Date:	28 Mar 2008
Refer to:	L080029-00
Subject:	Response to Comments and Questions on the COC Design Requirements Document (DRD)
Authors:	Helena Armandula, GariLynn Billingsley, Bill Kells, Gregg Harry (COC PDR team) and the COC PDR review committee: Doug Cook, Dennis Coyne (chair), Peter Fritschel, Eric Gustafson, David Reitze, Norna Robertson, Ken Strain, Bill Tyler, Hiro Yamamoto

COC Design Requirements Document (DRD)

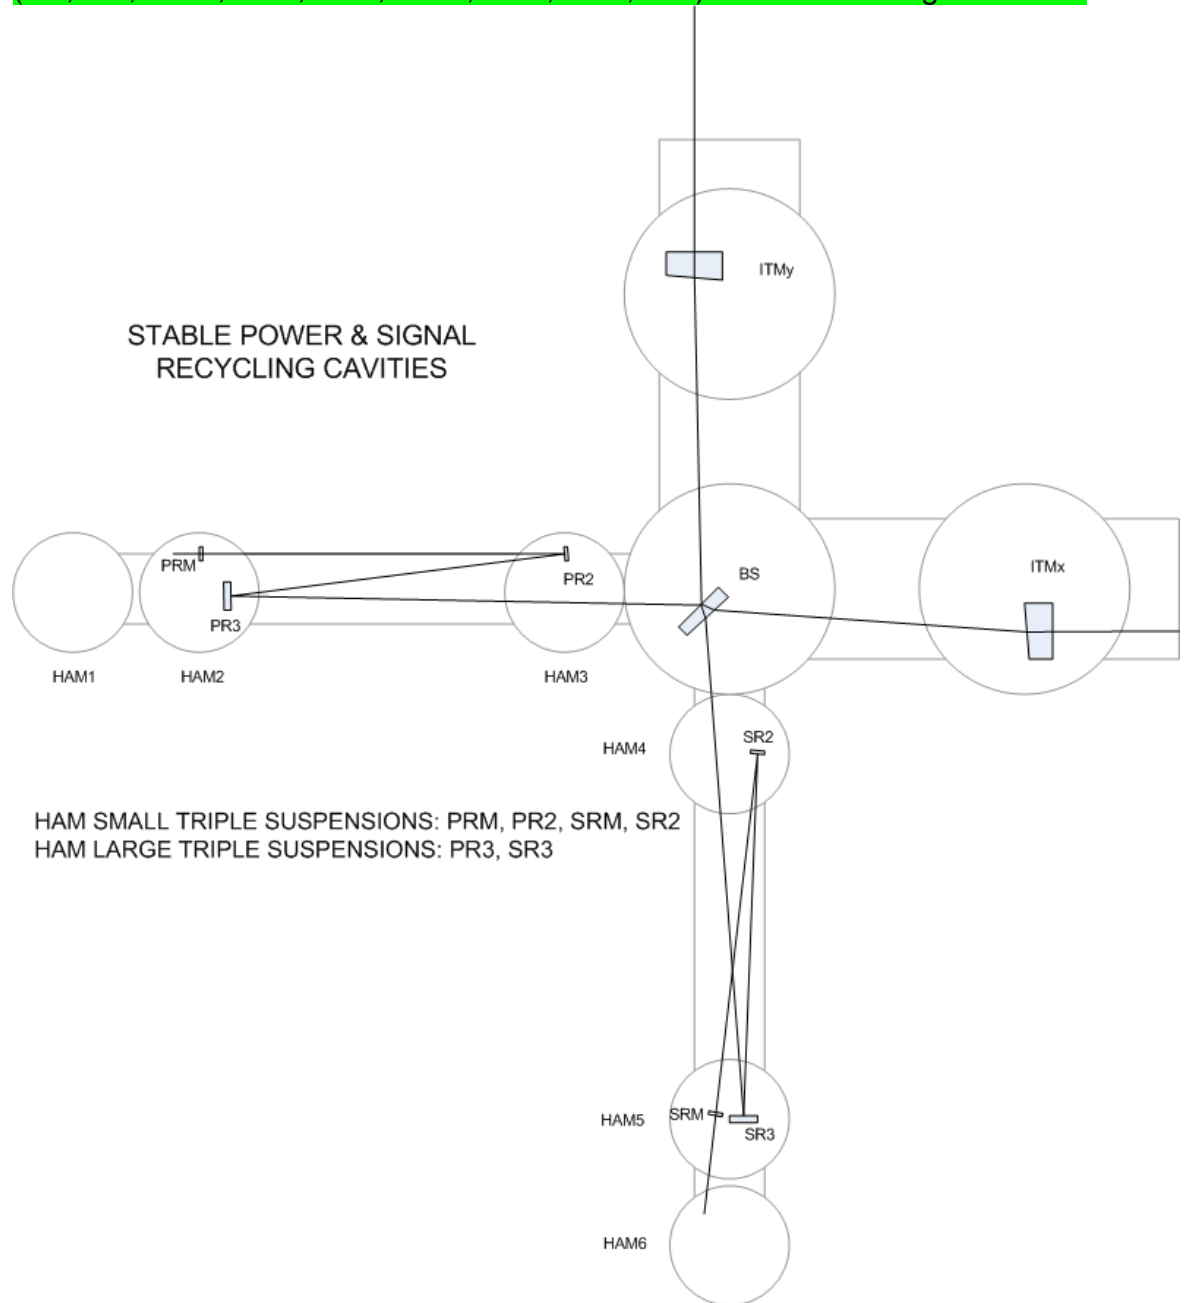
a. Please include a simple diagram showing the COC and IO elements with labels (BS, CP, PRM, PR2, PR3, SRM, SR2, SR3, etc.) similar to the figure below.

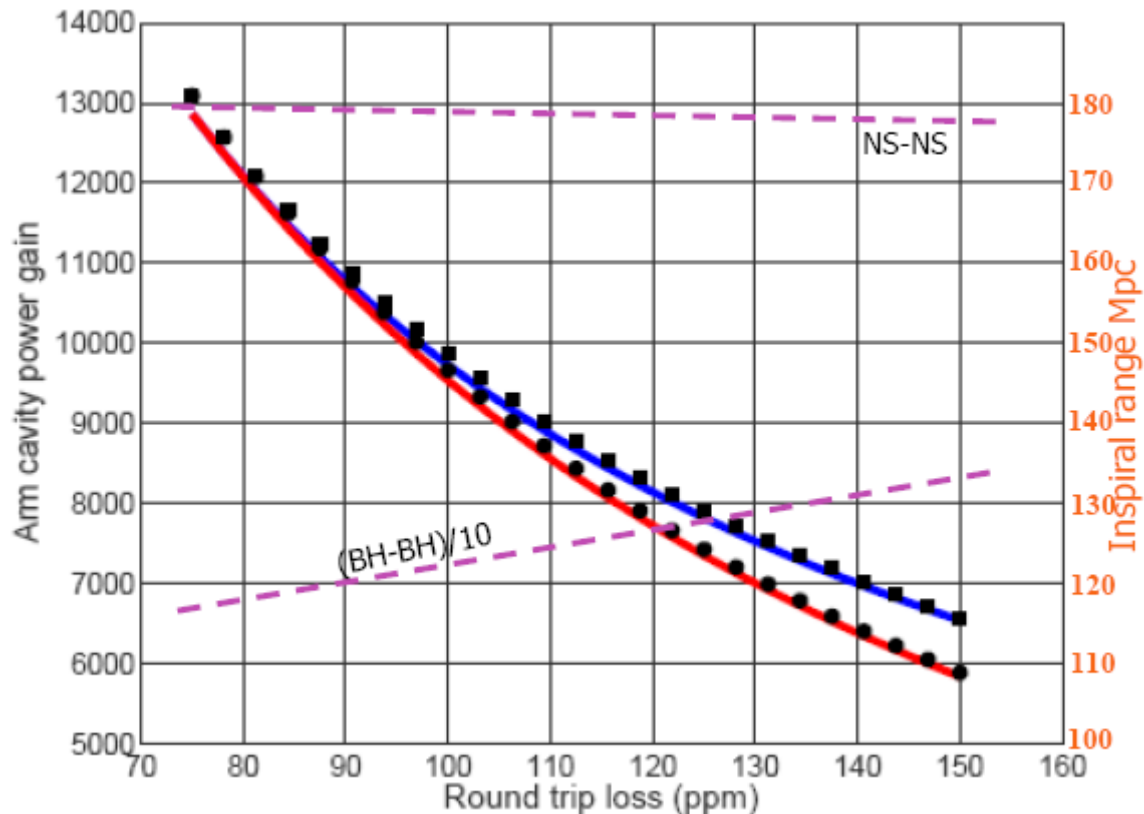
- 35) Section 4.2.2.5.3: In several of these questions pertaining to the dominant [scatter] loss in the advanced LIGO arms it can help to appreciate what the incremental IFO performance loss would be for ~1-10s ppm arm cavity loss variations. One illustration of this is (Figure 2.... inserted here): We agree that a discussion of the (in)sensitivity of various sources to arm cavity loss should be included in the DRD in order to put the loss budget goal of 75 ppm into proper context. The motivation for the 75 ppm loss budget is that this is the best that we might reasonably expect to achieve.

the remainder bounds the prompt loss of this section, we just reach the limit of table 4. Though this only demonstrates "0.7nm" as being marginally sufficient, additional appeal to Figure 2 (above) indicates weak consequence.
